BELLAIRE PROPERTIES INC. (CARSON’S CREEK)
PURCHASER EXTRAS

LOT # 062 P.E #005 – Model - KAHSHE - 3000 - PHASE 2

Schedule B-3 – Purchaser’s Extras
forming part of the Agreement of Purchase and Sale

The Kahshe / Elev. A & B
3000 Sq.ft.

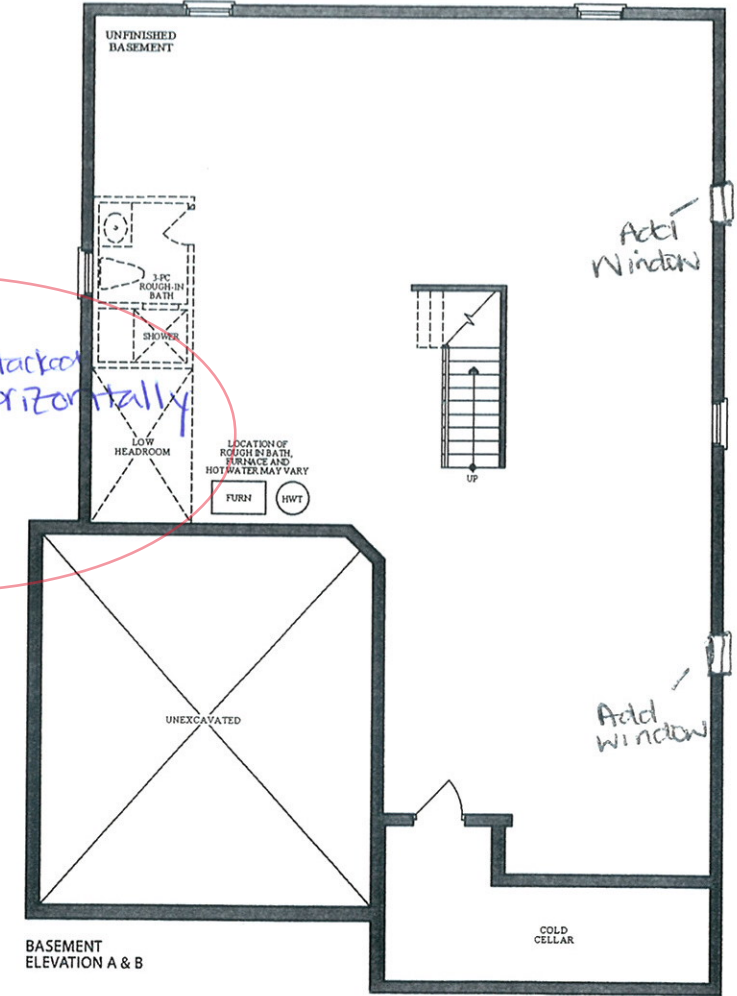
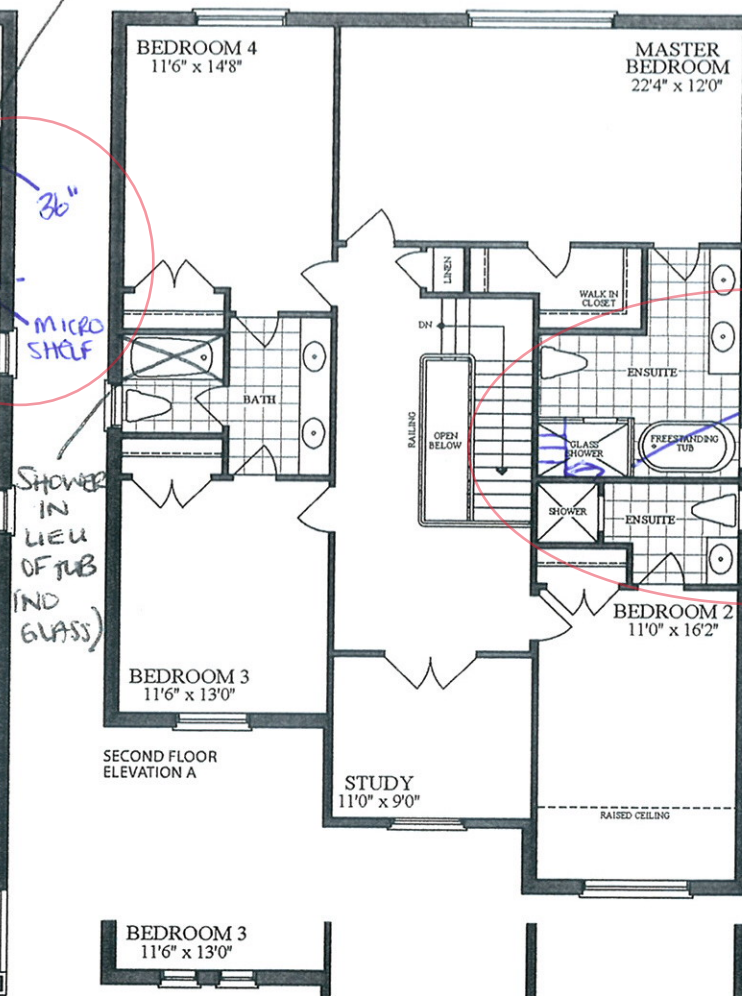
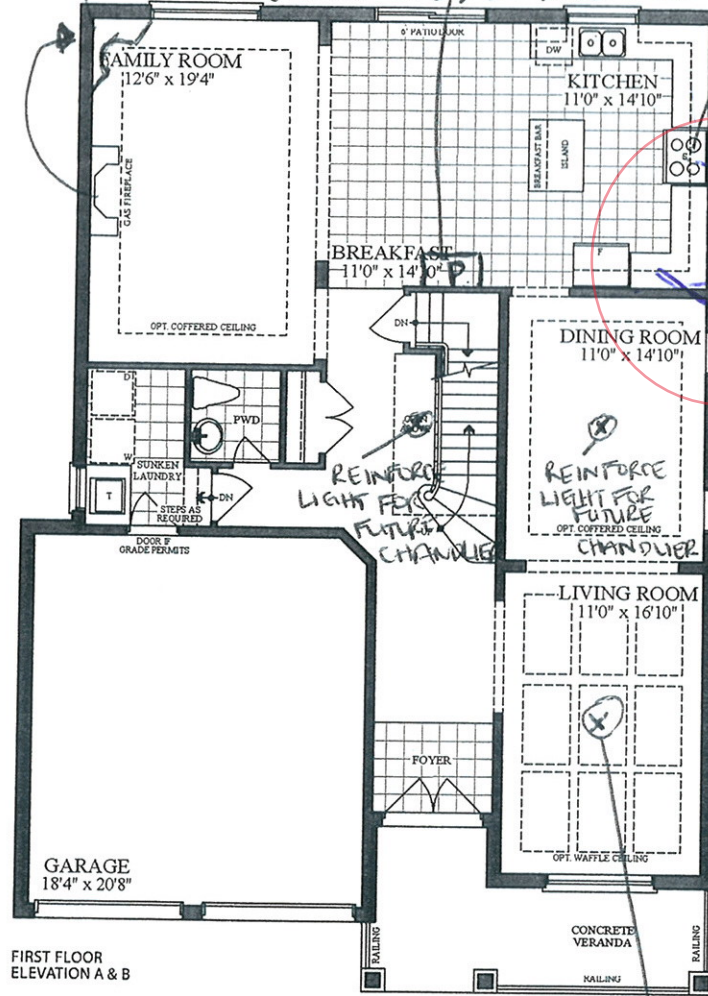
RELOCATE FIREPLACE
TO THE CORNER

PANTRY:
WINDOW TO BE SHIFTED
→ (NOT CENTERED) 2' FT DEEP
BY 39" INCHES WIDE

FUTURE
CHIMNEY HOOD FAN
CENTER VENT AS
MUCH AS POSSIBLE
